Arun District Council

Reference: BE/76/15/HH

Location: Spinney Cottage, Shripney Lane

Enquiry: Foreseeable damage to trees for a single story extension

Fig.1

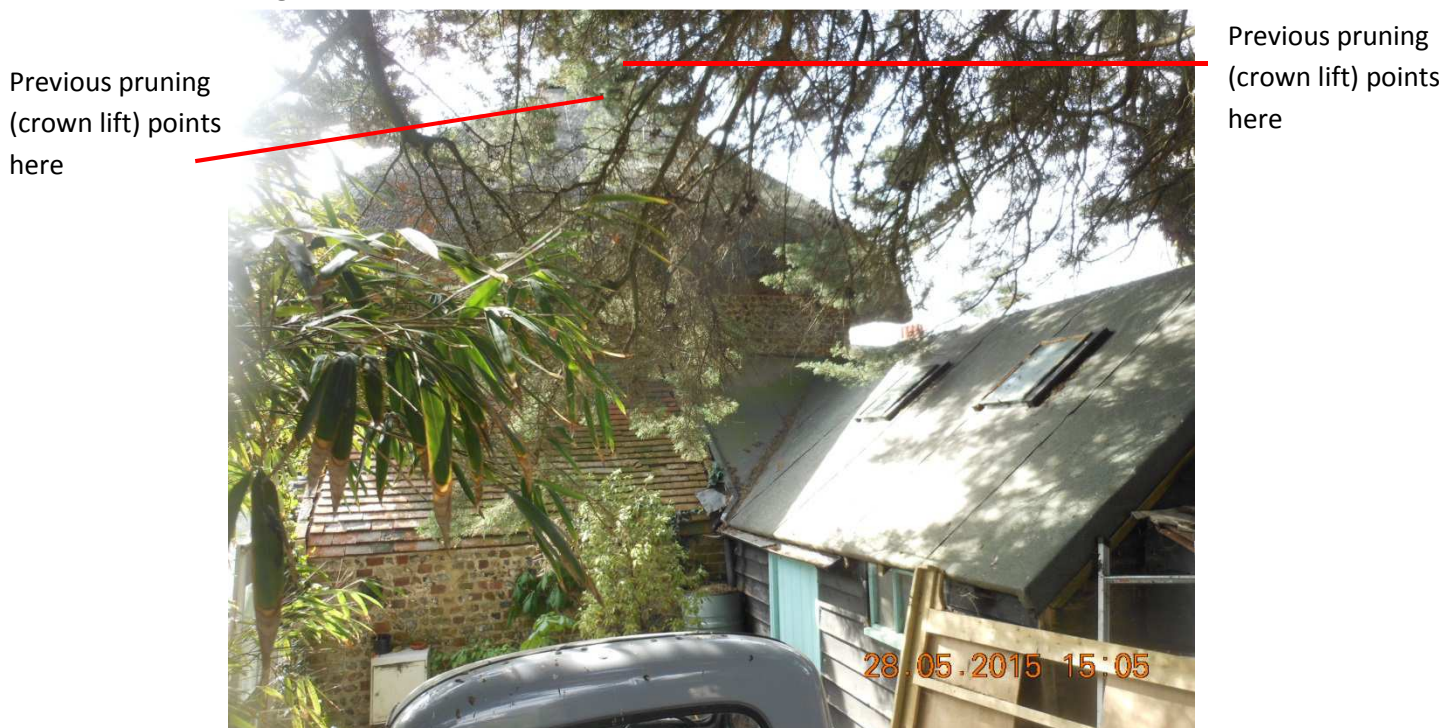
- It is clear from the site inspection that a number of branches will have to be removed to facilitate the proposed single story dwelling; this does include the branches cited in **Fig.1**. It should be noted that the cited Cypress tree has had a previous crown lift (to a height of 4 meters about at some point (judging by the regrowth for at least 3 years ago)).

- Judging by the size of the proposed extension, the established pruning points shown in **Fig.1** may have to be taken back further. There is also evidence of a previous lateral reduction to the western extremities of the cited cedar. Again to facilitate the proposed extension a reduction that surpasses the established pruning points may be required.
